**Re: Comments for the Bureau of Ocean Energy and Management's Draft
Environmental Impact Statement for the Vineyard Wind Proposed Wind Energy
Facility, Docket Number BOEM-2018-0069**

ATTACHMENT A
National Marine Fisheries Service's Comments on
BOEM's Draft Environmental Impact Statement (DEIS) for the
Vineyard Wind Offshore Wind Energy Project (BOEM 2018-0069)

Figure 1: VMS fishing effort (0-5kts) for Atlantic Mackerel, Squid, and Butterfish trip declarations, 2010-2018. The Vineyard Wind Lease Area is outlined in red.

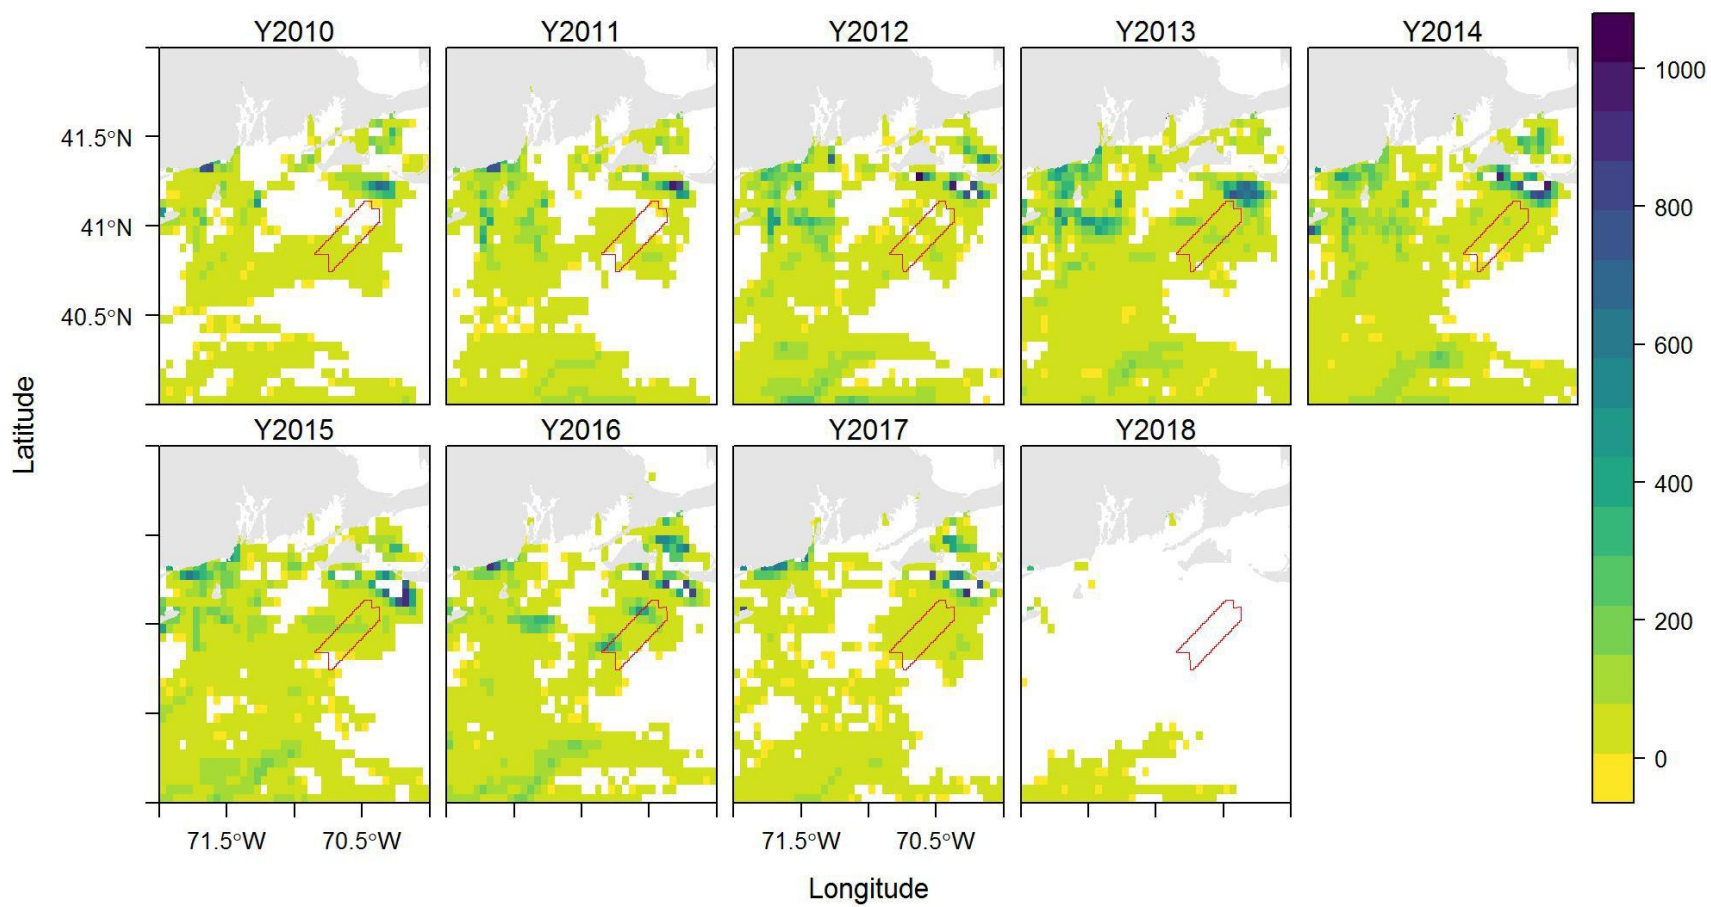
On page 3-163, the second paragraph states “Comparison of VMS data in 2015-2016 shows intensive use of the area for squid fishing (Figure 3.4.5-2). That is not an accurate description of the data. The data used for Figure 3.4.5-2 do not indicate squid fishing intensity, but rather the relative squid fishing vessel intensity during the year 2015-2016. VMS data show vessel presence, but do not indicate whether the vessel is fishing or not. This should be clearly indicated in the text, figure caption, and map legend. It has become a standard practice to “speed filter” VMS data so that maps better indicate likely fishing activity. Both speed-filtered and unfiltered VMS data are available from the Northeast Ocean Data portal for most fisheries. This figure should be created using the speed-filtered VMS data, which indicates vessels traveling at speeds less than four knots, which would more accurately depict squid fishing activity.
